# **Response to Submissions**

**State Significant Development Application (SSD 10349)**

**Multi-Trades and Digital Technology Hub**

**TAFE NSW Meadowbank Campus  
Meadowbank Education and Employment Precinct**

Figure 10: Revised SSD project boundary (Source: Gray Puksand)

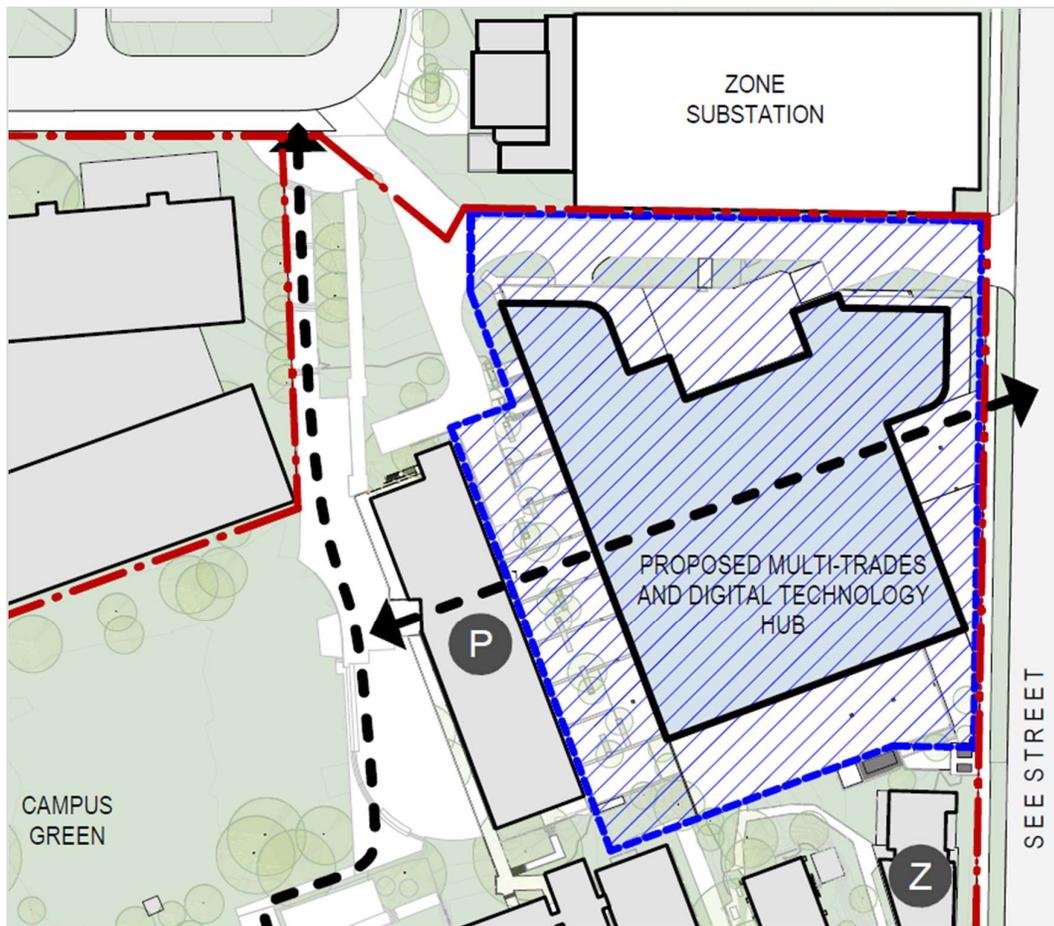
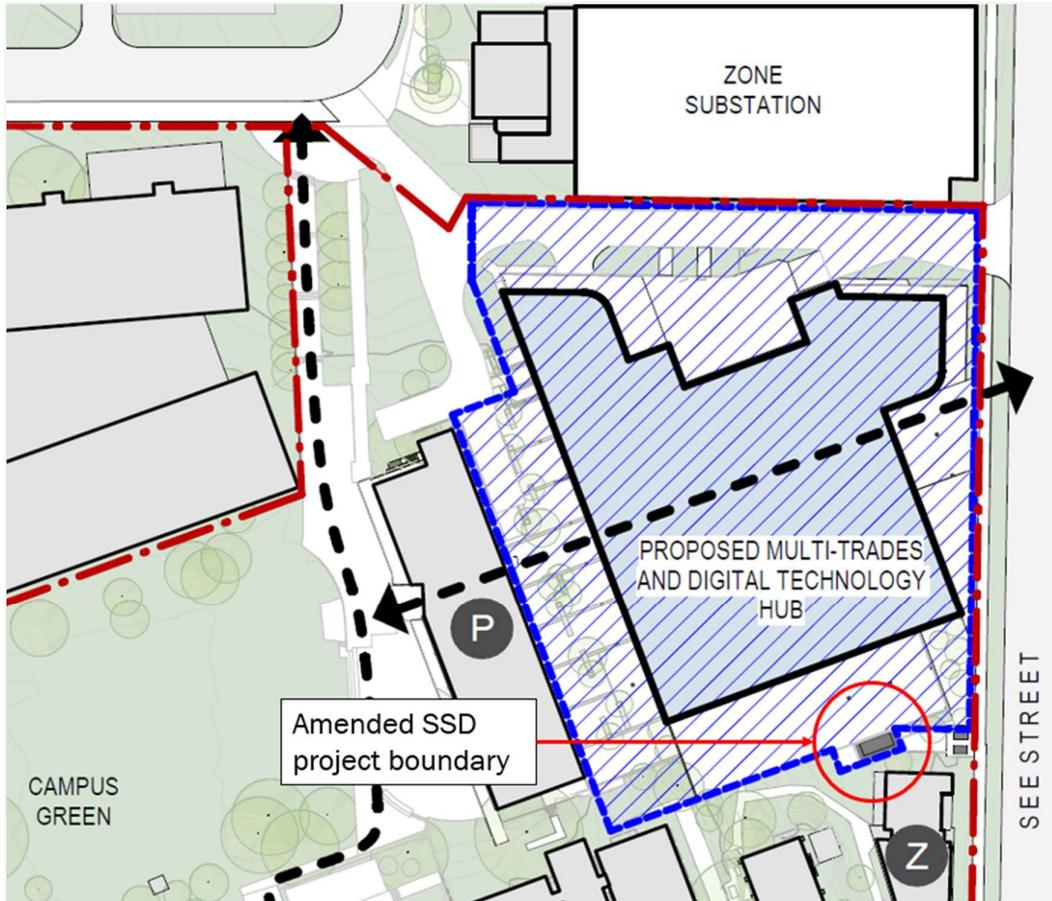
The SSD application boundary is amended as part of the RtS to include the footprint of the new multi-storey car park at the south-eastern part of the site. The SSD application boundary encompassing both the Multi-Trade and Digital Technology Hub and the new multi-storey car park is shown in Figure 1.

It is acknowledged that the SSD application boundary now includes the fuel tank and generator services rooms at Level 03 (one storey below See Street level) of the Multi-Trades and Digital Technology Hub building, which has been amended following submission of the EIS.

The SSD application boundary, as proposed in the EIS, is shown at Figure 9. The amended SSD application boundary, proposed as part this RtS, is shown at Figure 10.
